A/KTN/97 Lot No 263 Kwu Tung North NDA
31/01/2023 02:23

Fanling Sheung Shui Town Lot No. 263, Kwu Tung North NDA

**APPLICATION FOR PERMISSION
UNDER SECTION 16 OF
THE TOWN PLANNING ORDINANCE
(CAP.131)**

Supporting Planning Statement

Figure 3: Local Open Space in Ground Floor

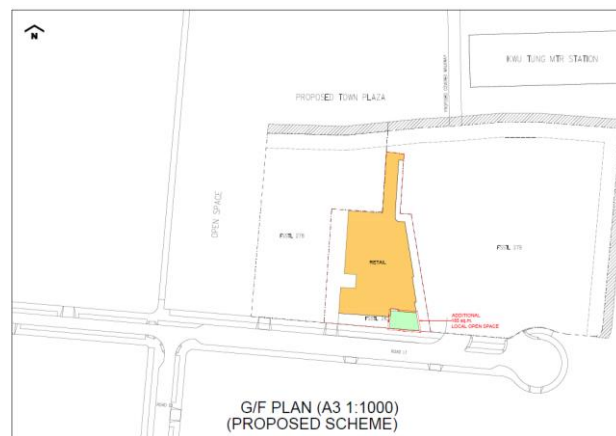
So the additional OS is in the form of a small plot that has been added, it appears, at Ground Floor. As the lower floors are retail it is inconceivable that residents could enjoy exclusive use of this space. This in a development where some of the units are less than 200sq.ft. and cooking facilities are open to the living/sleeping area.

G/F OPEN SPACE PLAN (A3 1:100) (PROPOSED SCHEME)

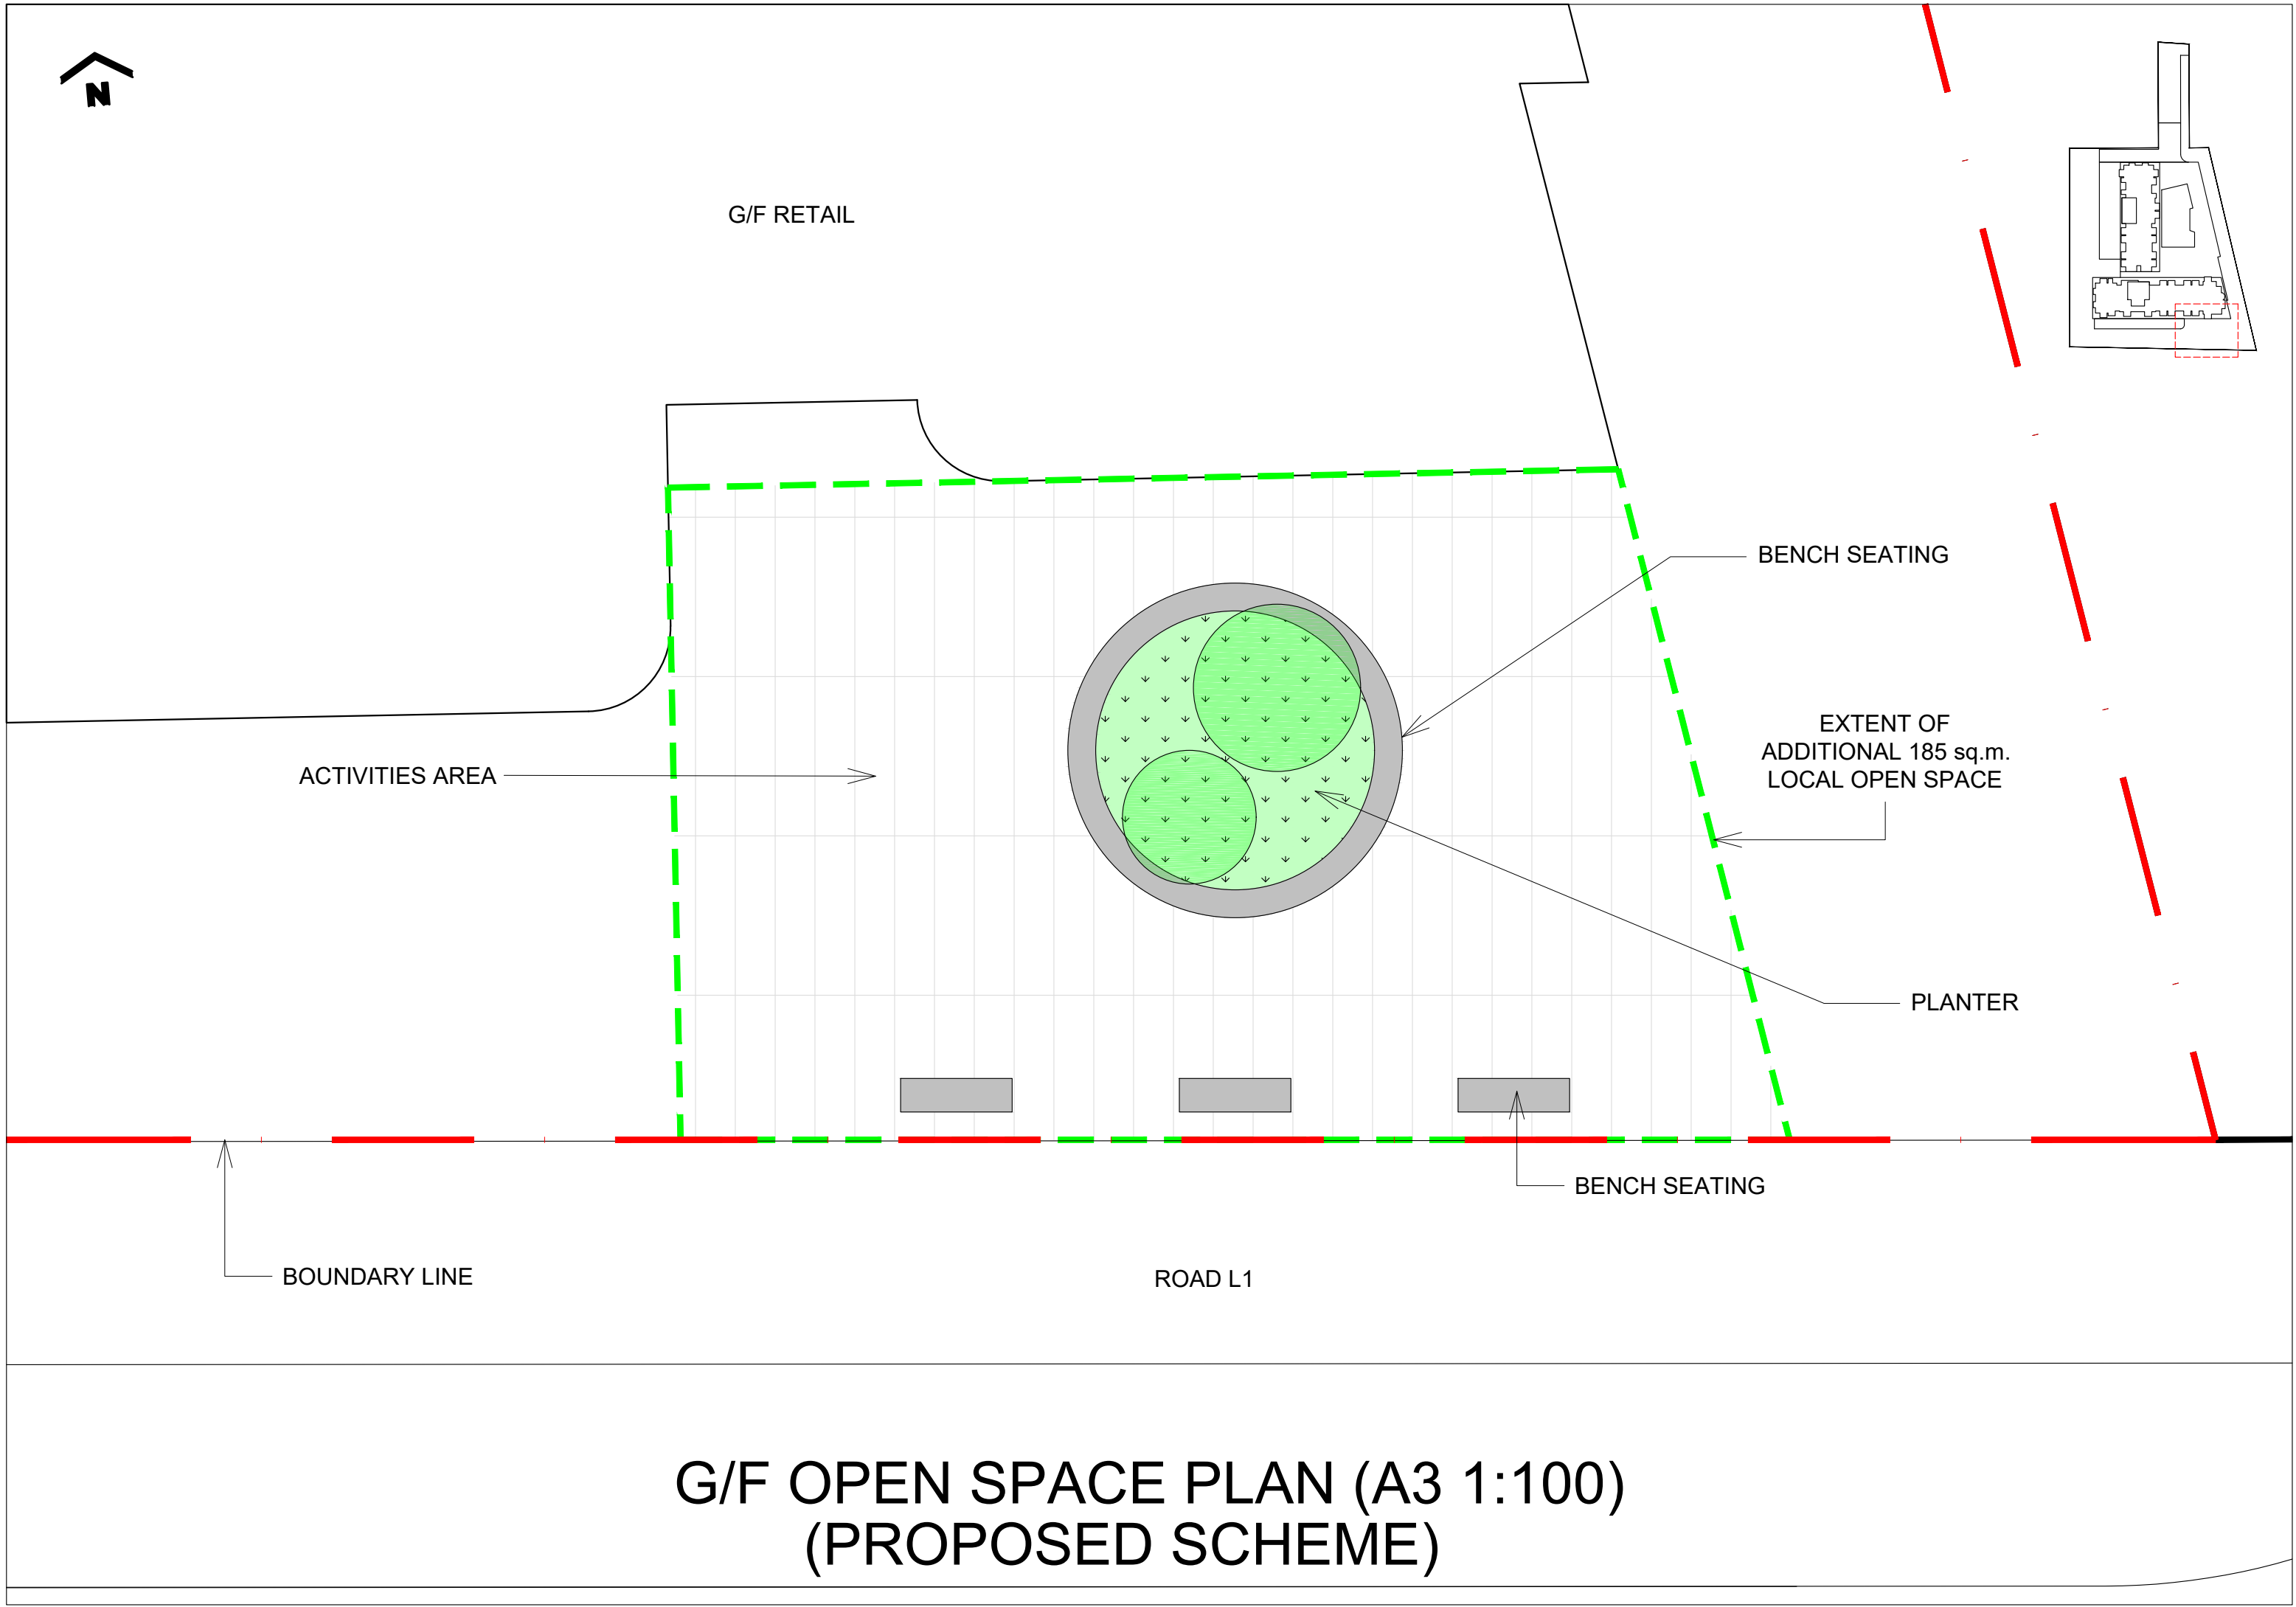
- (f) To note the comments of the Chief Town Planner/Urban Design and Landscape, Planning Department that:
 - (i) the applicant is advised to demarcate the extent of proposed landscape area on the Master Layout Plan and clarify the landscape treatments to be provided within the Site. Landscape plans, sections, elevations with self-explanatory legends and descriptions, spots levels, typical planting detail and proposal etc. are advised to be provided to illustrate the landscape considerations and treatments within the Site; and

- (ii) with reference to Table 3.1 – “Comparison of Key Parameters between Base GBP and Proposed Scheme” of **Appendix Ia**, it is specified in item 14 that Local Open Space (not less than 1 m² per person) of 2,587 m² shall be provided for the proposed scheme. The applicant is advised to provide Open Space Demarcation Plan indicating the proposed local open space for reference.

EXTENT OF
ADDITIONAL 185 sq.m.
LOCAL OPEN SPACE

Figure 2: Proposed Road Network as per Traffic Impact Assessment submitted by CEDD

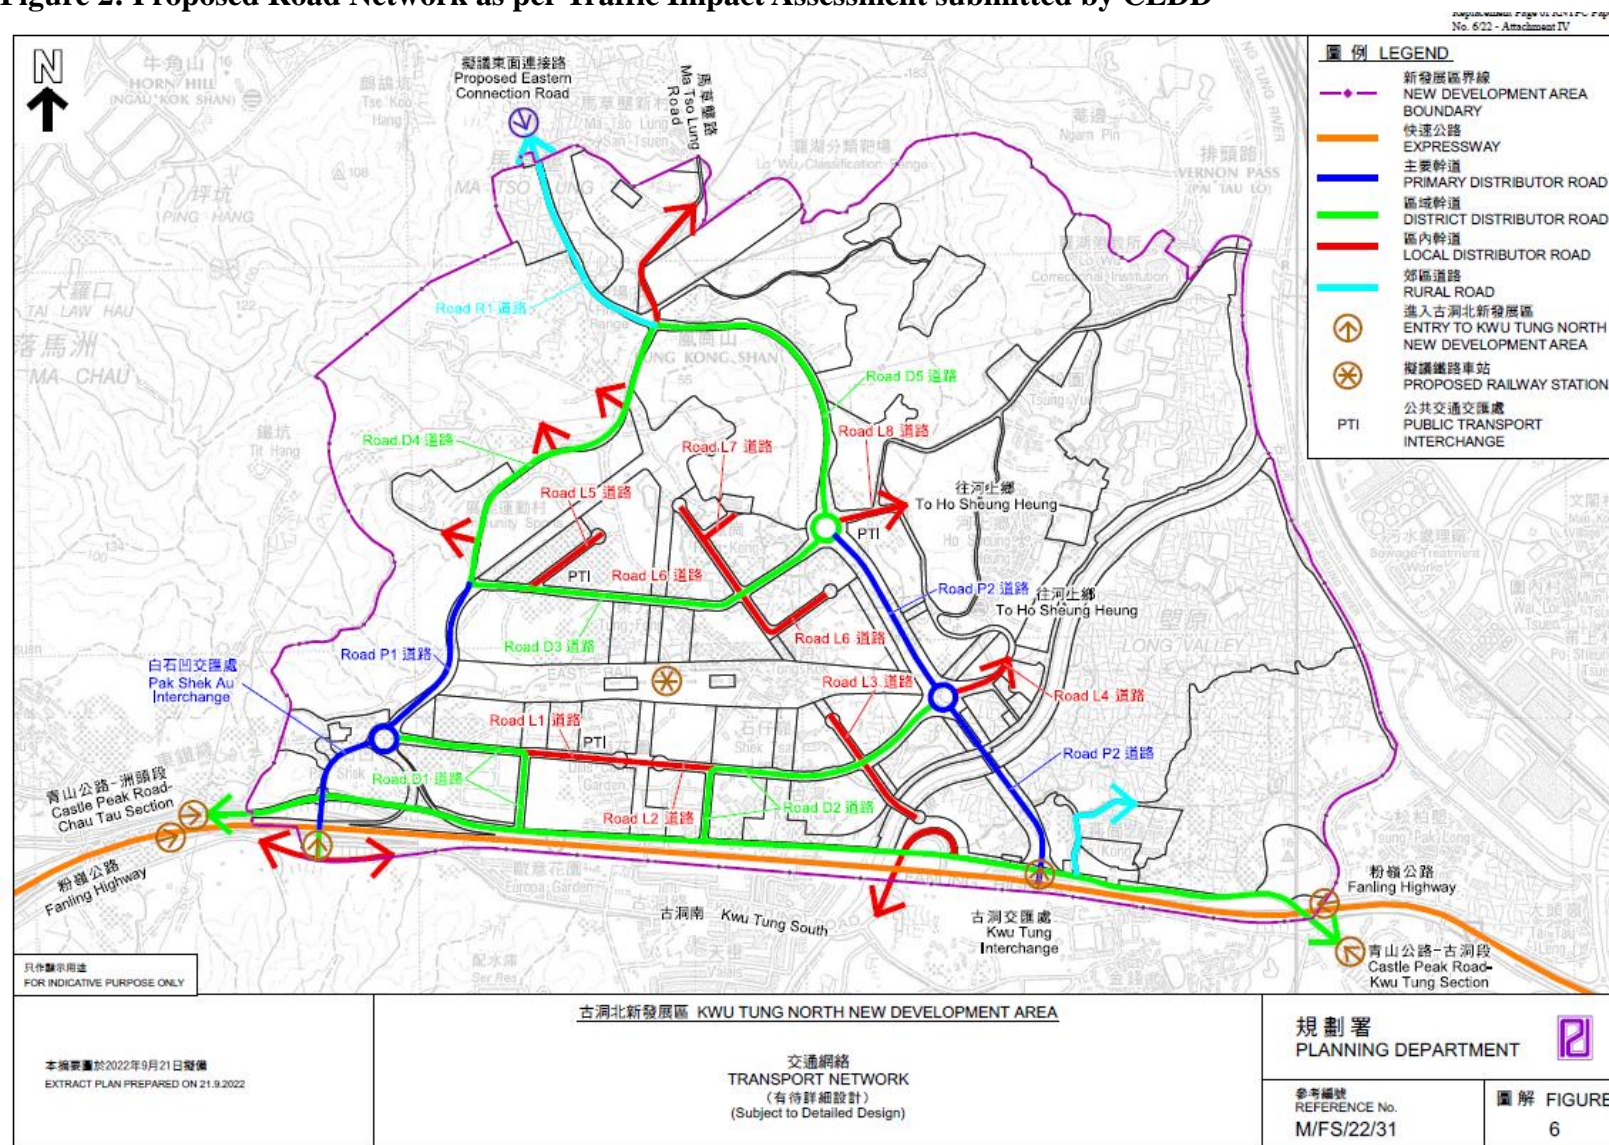
(2) It is noted that the captioned planning application will introduce more vehicular trips to the new roads and junctions which are being designed and constructed by CEDD in the KTN NDA projects. TD relies on CEDD to deliver an adequately designed road networks and junctions to TD for management. Please obtain CEDD's agreement that the additional trips under the subject planning application could be accommodated by the roads planned by CEDD.	CEDD's TIA public document is made available for reference and it revealed sufficient spare capacity in the rezoning and s16 applications. According to the published TIA in TPB Paper (RNTPC No. 6/22) and Application A/KTN/93 approved by TPB on 23.9.2022, it is no doubt that the road system has spare capacity to take care of the additional 8 pcu due to the proposed minor relaxation during AM peak hours (Annexes A and B in the attached) as RC is more than 25% (max. 71%) and VC is max. 0.59 in the design years.

(3) Despite my comments in Para (2) above, we have the following observations on the submission; (a) Table 4.2 – It is observed that the applicant has not included the base trips and total trips in the table. Please check; (b) As shown in the MLP in Annex 1, the run-in/out of the subject development will be at the Road L1 under CEDD. Please seek CEDD's comment; and (c) This is to reiterate that the assessment from the applicant is based on the assumption that the proposed traffic improvement measures such as the new roads and junctions of KTN NDA by the others. The applicant should note that these traffic improvement measures are uncertain at this moment and subject to changes during the course of the project development. In case those traffic improvement measures would not be	(a) Annex A showed basic total flow in the reference case which has already included the planned PR5's trips (i.e. KL17 NB 430) on site. Therefore even if the additional 5pcu generated are all concentrated in NB, the scenario in KL17 NB is 435 pcu (new total flow) on Road D1 in the AM peak which is insignificant. (b) The traffic generation of 8pcu is insignificant and the TIA of CEDD (Annex A) reveals the spare capacity. (c) The proposed road improvement works to be carried out by Government to meet community demand and commitment to the 2 adjoining sales sites (Wheelock and SHK) which are supposed to be completed for the occupation around 2025/26. The relevant junctions

Public information is available to demonstrate the spare capacity is available to accommodate the **8pcu** (due to the proposed minor relaxation of PR0.5) during morning peak in the road network (**Figure 1**). The basic information from TPB Paper (RNTPC Paper No. 6/22 dated 23.9.2022. Junctions and Links relevant to the subject development (**Figure 2**) are KJ15, KJ16 and KJ18; and KL16 (Road P1) and KL17 (Road L1) and there are spare capacity in 2031. 2036 and 2041 are listed in the tables below:
